4103 standard st. Davidson Manor HAWAII
Cherry Chase 35/129-08A

APPLICATION FOR
HISTORIC AREA WORK PERMIT

Address:	4103 Stanford Street, Chevy Chase	Meeting Date:	9/10/08
Applicant:	Marina Krapiva	Report Date:	9/03/08
Resource:	<i>Master Plan</i> Site #35/129, Davidson House	Public Notice:	8/27/08
Review:	HAWP	Tax Credit:	Partial
Case Number:	35/129-08A RETROACTIVE	Staff:	Anne Fothergill
PROPOSAL:	Window and door replacement, retaining wall construction, storm window installation, and removal of rear deck and construction of new deck

Address: 4103 Stanford Street, Chevy Chase **Meeting Date:** 5/14/08
Applicant: Marina Krapiva **Report Date:** 5/07/08
Resource: *Master Plan* Site #35/129, **Davidson House** **Public Notice:** 4/30/08
Review: HAWP **Tax Credit:** Partial
Case Number: 35/129-08A **RETROACTIVE** **Staff:** Anne Fothergill
PROPOSAL: Window and door replacement, retaining wall construction, storm window installation, and other alterations

*Proposed revised
plan*

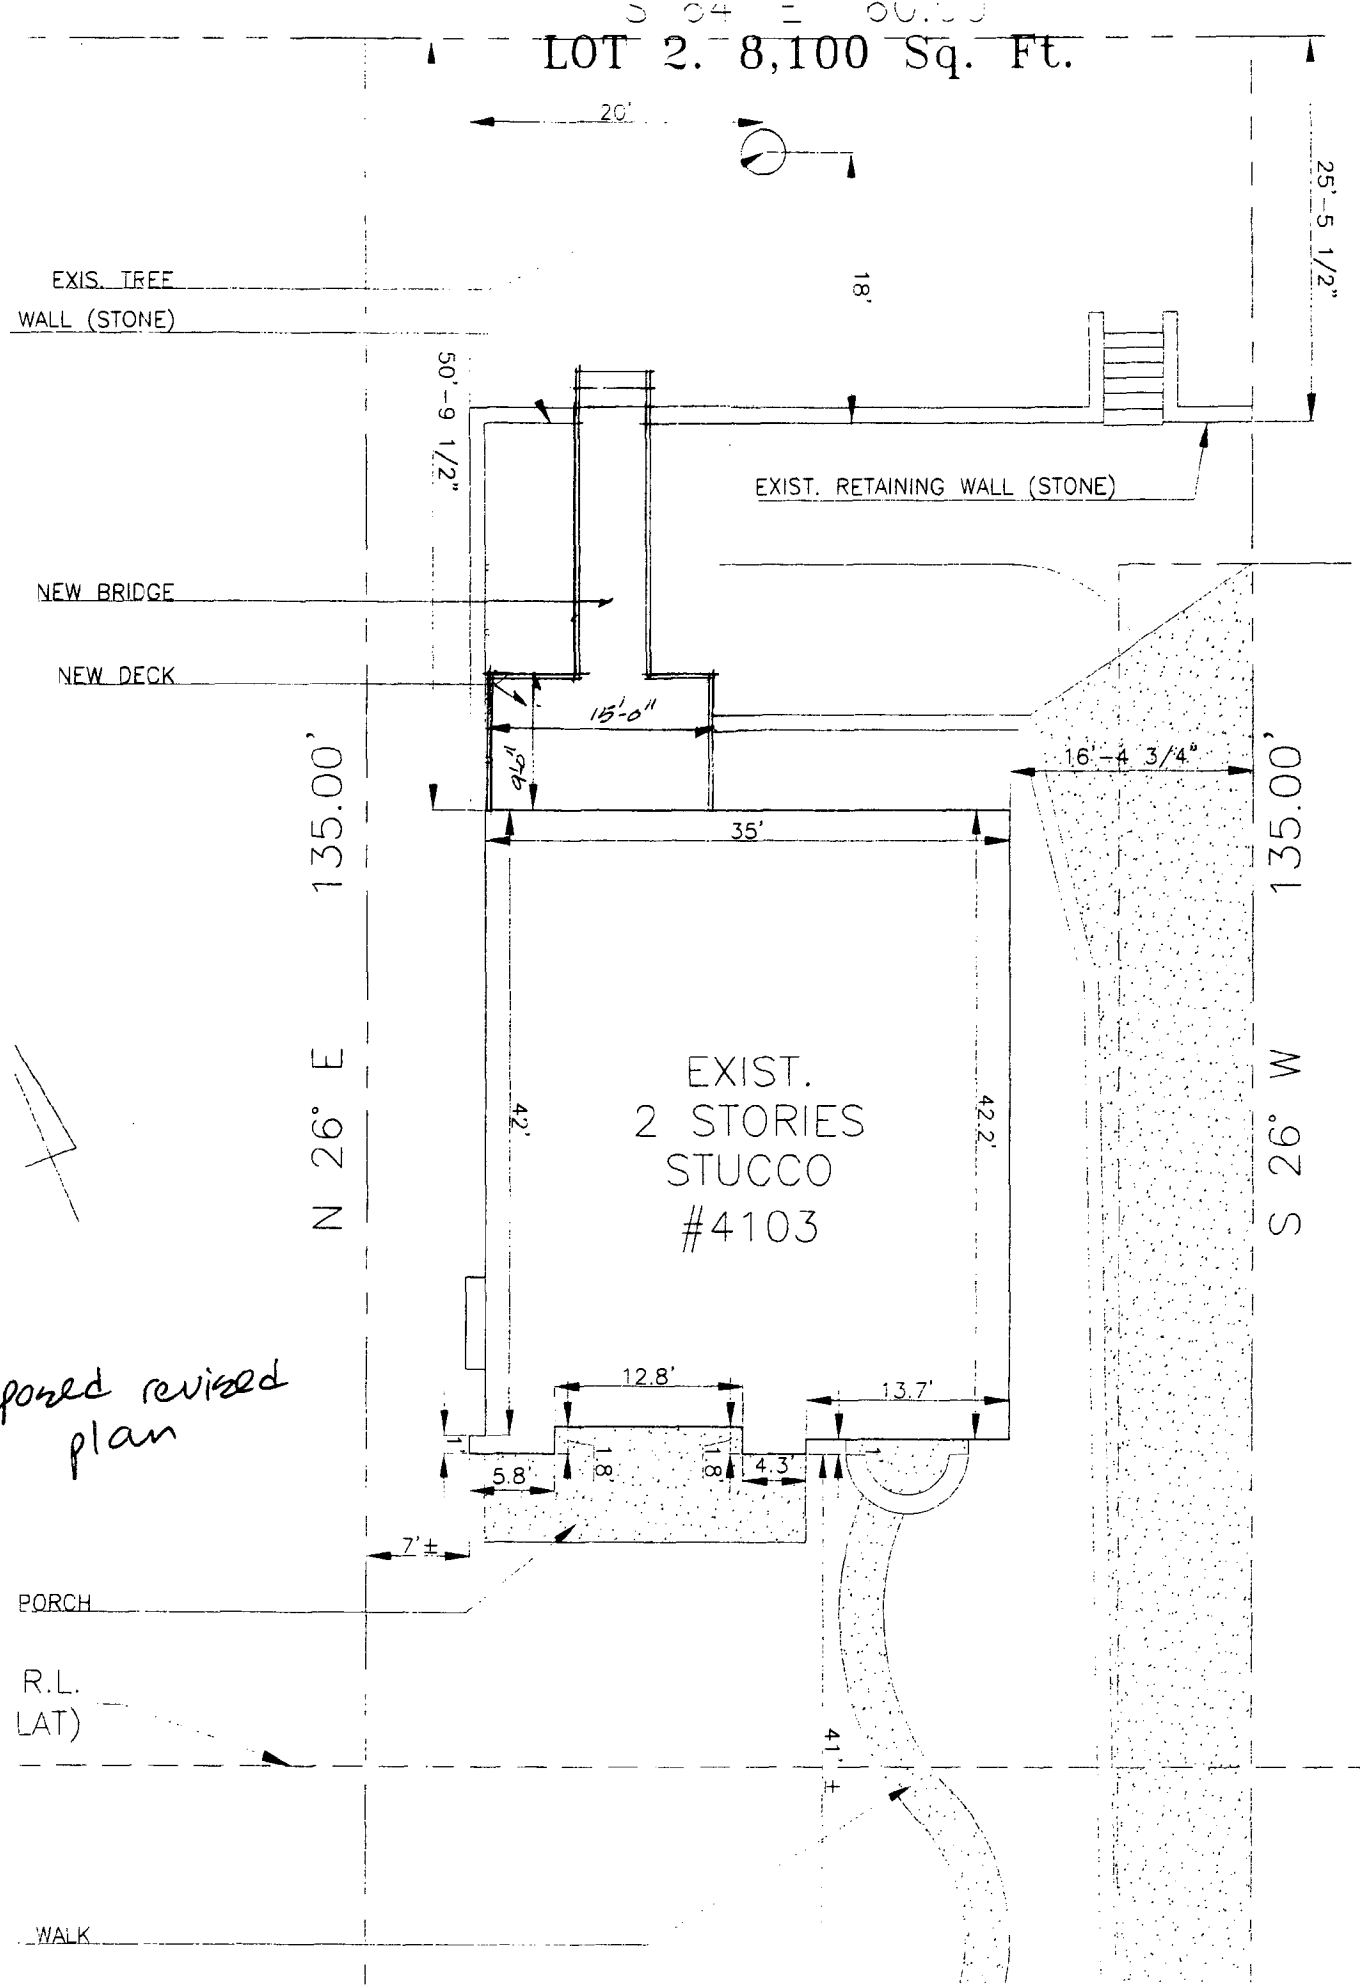
In October 2008 the HPC approved a deck replacement at the rear of this house. The applicant is now proposing minor changes to the shape and detailing of the deck and staff is requesting that the HPC allow these changes to be approved at the staff level. Approved and revised plans are attached.

Sheet Number:
A-2 / 4

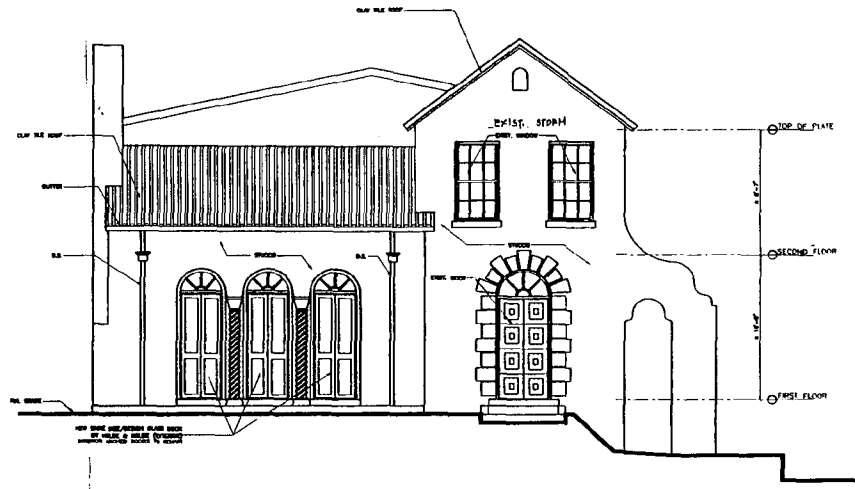
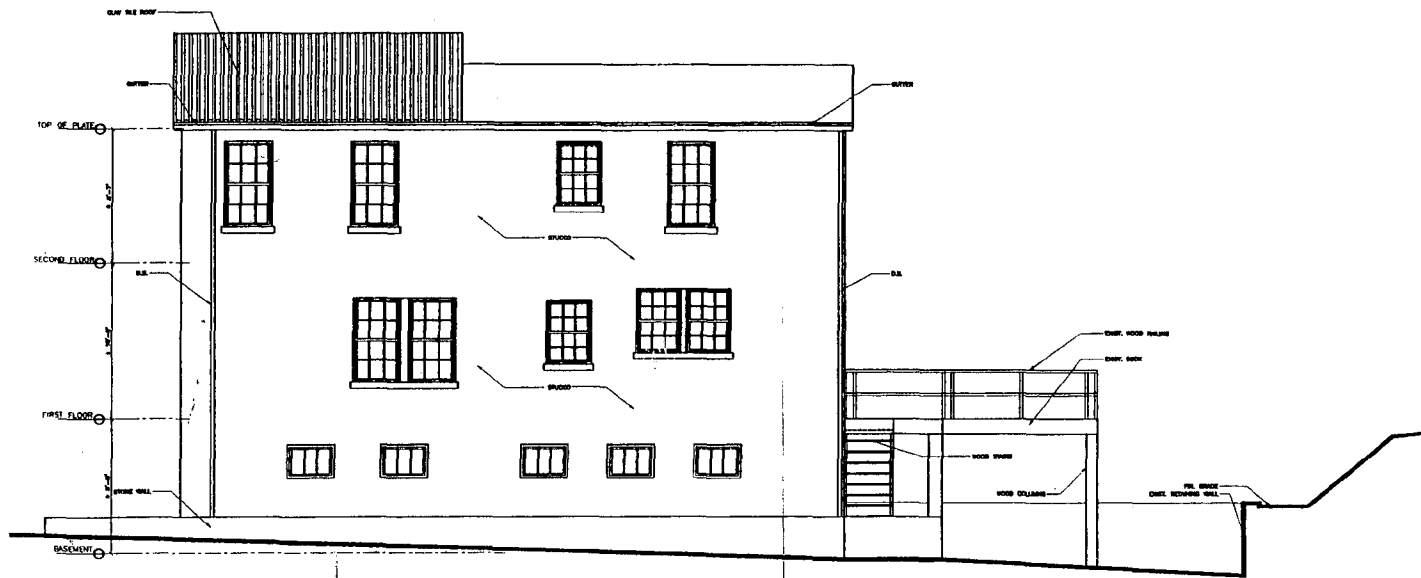
So what the applicant is proposing on the right side is to replace five windows at the foundation level, with wood simulated divided light windows. That work has been completed. These changes are at circles 10 and 15. And then to replace two windows on the first floor with wood windows with true divided lights in the original opening.

So what has happened is, the windows have been replaced with wood simulated divided light windows that are smaller than the original windows. And the applicant has now amended the application to propose replacement of wood windows, true divided light that would be the correct size of the original opening. That is a change.

Right side: staff supports the proposed change to wood TDL custom-made replica windows in the original openings.

Proposed custom-made
Front doors

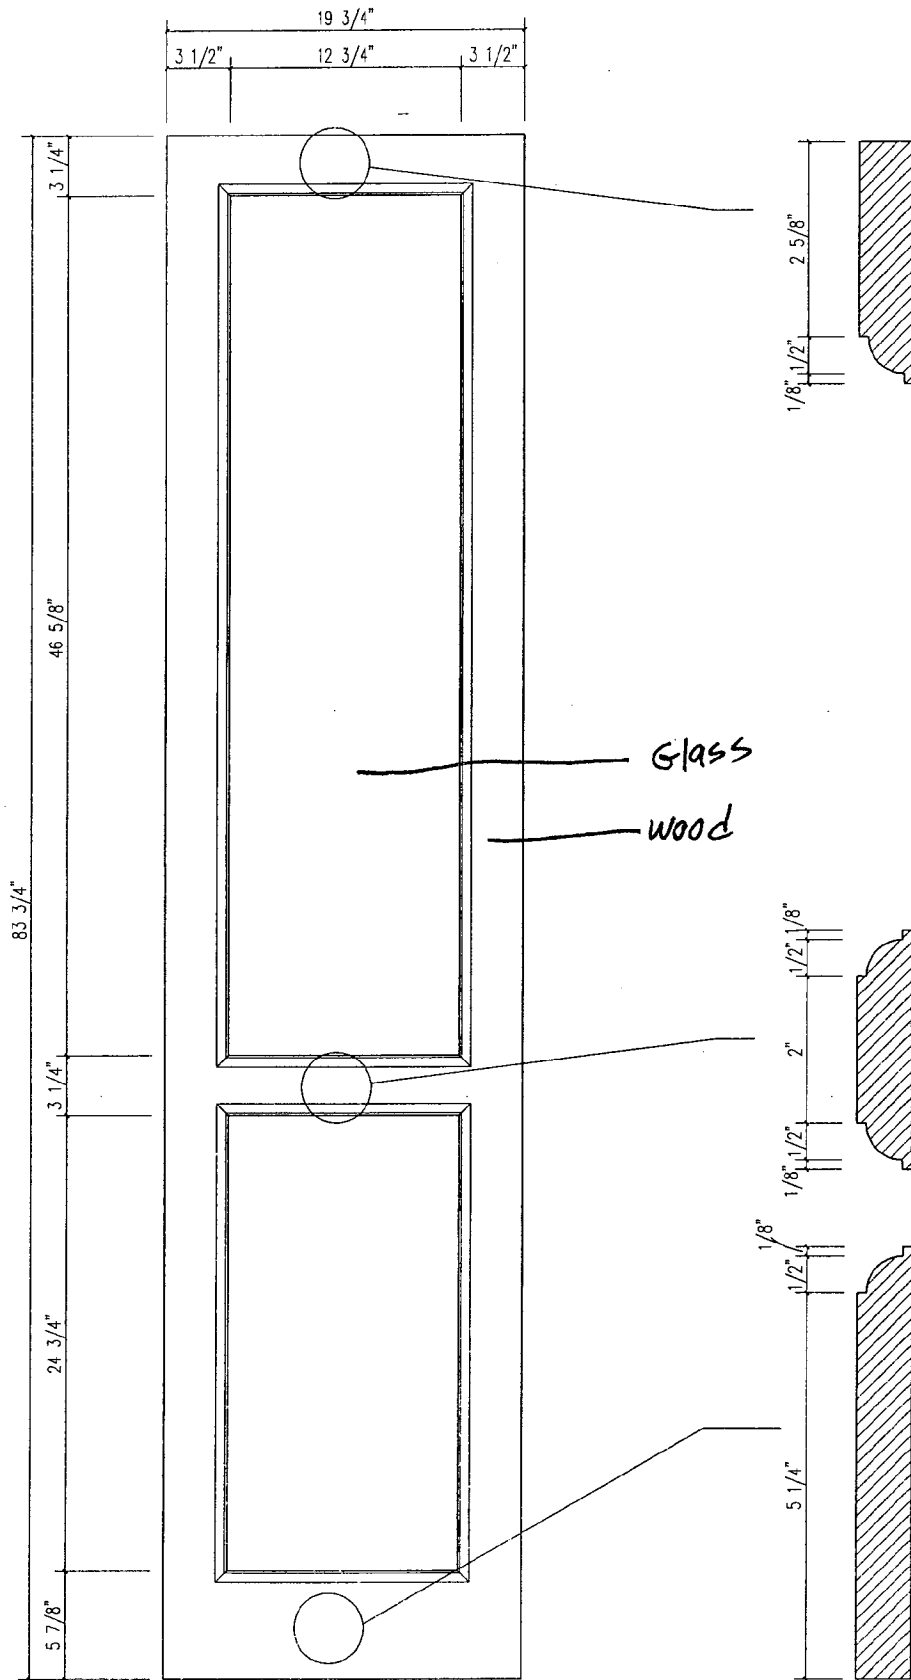
Another change since you reviewed it in May is that on the front those three doors currently have screens, wooden screen doors. And the applicant had proposed something, and actually, we received upstairs that the applicant has changed the application and is now proposing metal storm doors. This is the manufacturer and she can tell you more specifically what she's proposing. But she's not proposing wood doors in those openings with the same size. She's proposing the Monray manufactured metal storm door.

Originally, the applicant had talked about PVC trim, and so staff just added conditional approval. It's not clear if that's being proposed or not, but PVC trim is not approved on this house. And then in terms of the metal storm doors, the applicant -- staff doesn't have a full submission, so the applicant will talk about it, but most likely that would not be in keeping with the Secretary of the Interior's standards, and staff would not support metal storms on the front elevation of that house.

Staff supports the new custom-made wood doors with glass with the same design and in the same openings as the screen doors on the front elevation. The applicant is proposing this change for security purposes, and the new doors will have a similar overall appearance as the original design. The Commission has approved changes to similar doors in an adjacent Geare house.

Proposed Deck

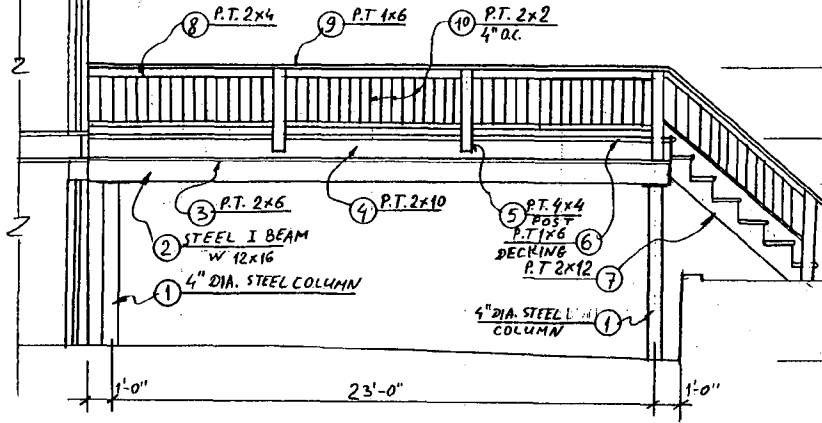
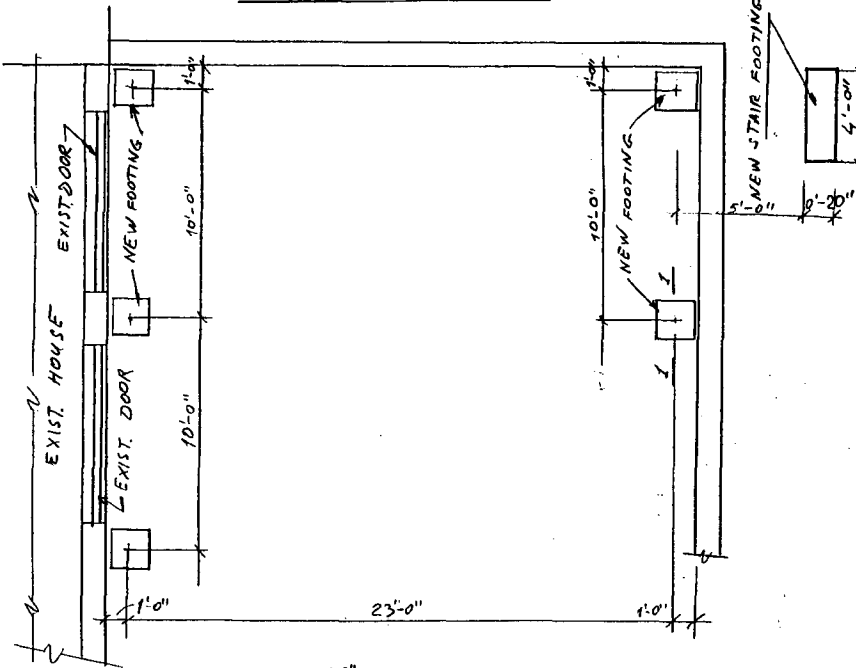
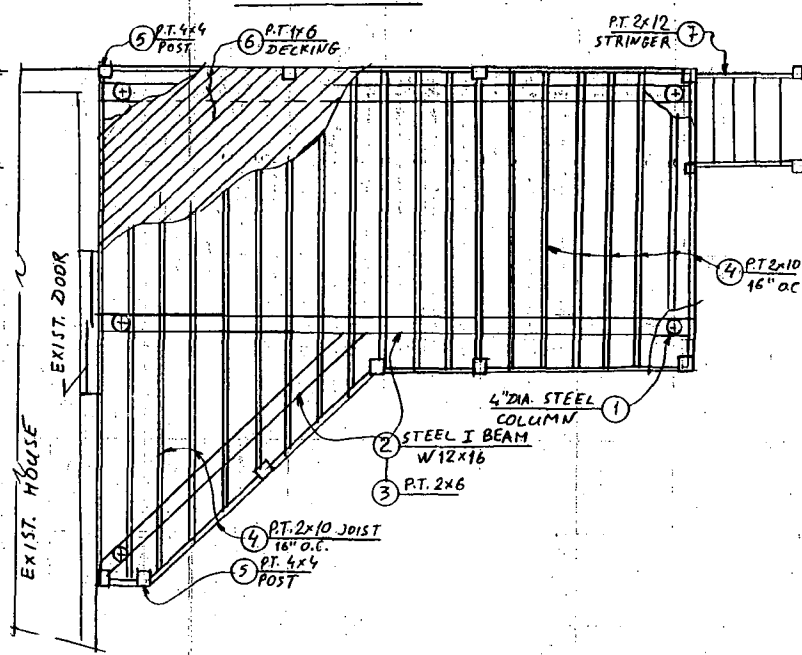
There is one partial site plan that gives a little bit of planning, but it really doesn't demonstrate anything about what's happening on the -- you know, it calls off a new deck. What's a new deck? Is it elevated? Is it on the ground? What's it made out of?

There's a new bridge. It's four lines on a piece of paper. It doesn't show us anything about what's been drawn or what's been proposed. I don't know how we can evaluate it.

The deck and bridge are also located at the rear of the property. The bridge will be visible from the back of the adjacent *Master Plan* resources and slightly visible from the street. Although the bridge from the deck to the yard may be an unusual installation, it will have minimal impact on the historic house and it is a reversible change.
